REV#	DWN BY	DESCRIPTION	DATE
A	SRP	ISSUED FOR APPROVAL	Jun 11 2025

PROJECT DESCRIPTION : CLEVELAND BROTHERS-MILESBURG

DRAWN BY : BAS	DATE : 05-20-25	PROJ. NO. : 25012	REV # A
CHECKED BY : SRP	DATE : 05-20-25	DWG NO. : SE220

DWG DESCRIPTION : SECTIONS

1 SE220 **SECTION**

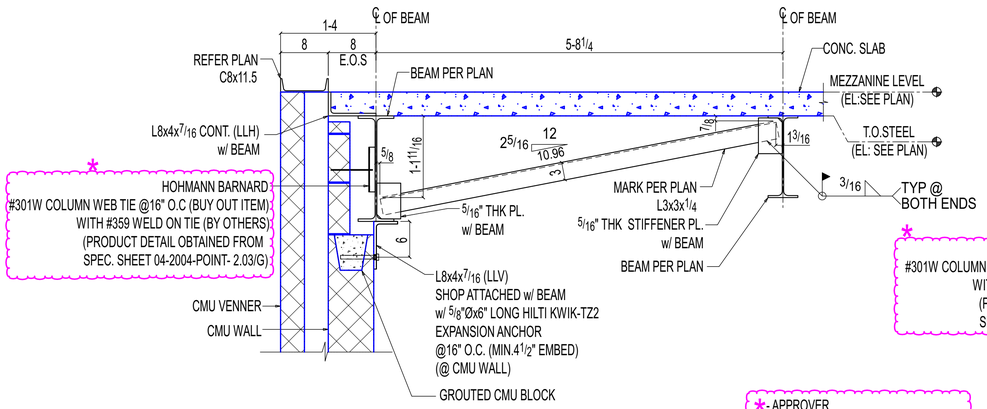
*- APPROVER,
PLEASE CONFIRM CLOUDED MASONARY
ANCHOR PRODUCT DETAIL AND SPACING
ARE OK TO PROCEED?

2 SE220 **SECTION**

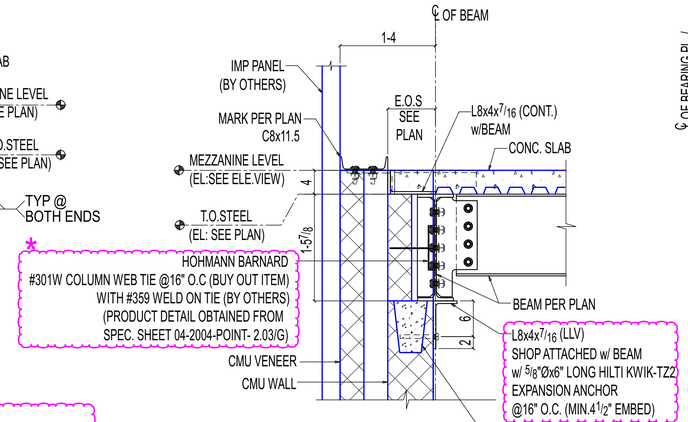
APPROVER
PLEASE ADVISE ON THE REQUIREMENT OF SLOT HOLES
FOR FIELD ADJUSTMENT ON THESE ANGLE SO THAT WE
CAN FIELD WELD IT TO BEAM AFTER ADJUSTMENT.
IF REQUIRED THE PLEASE PROVIDE SLOT LENGTH.

3 SE220 **SECTION**

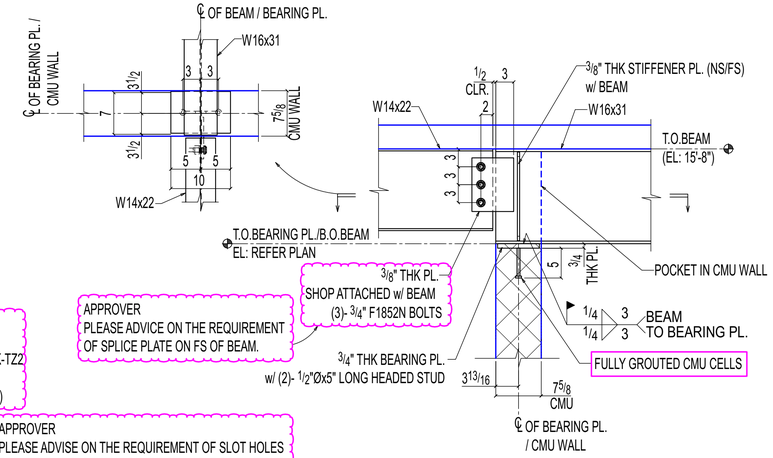
APPROVER
PLEASE ADVICE ON THE REQUIREMENT
OF SPLICE PLATE ON FS OF BEAM.

APPROVER
WE HAVE LOCATED THE HOLE ON THE GAGE LINE
OF THE ANGLE AT 2 1/2" AS SHOWN, INSTEAD OF 2"
AS INDICATED ON THE STRUCTURAL DRAWING.
PLEASE CONFIRM IF THIS IS ACCEPTABLE.

APPROVER
WE HAVR PROVIDED 1" SHORT SLOT
HOLE FOR FIELD ADJUSTMENT.
PLEASE CONFIRM IF IT IS ACCEPTABLE.
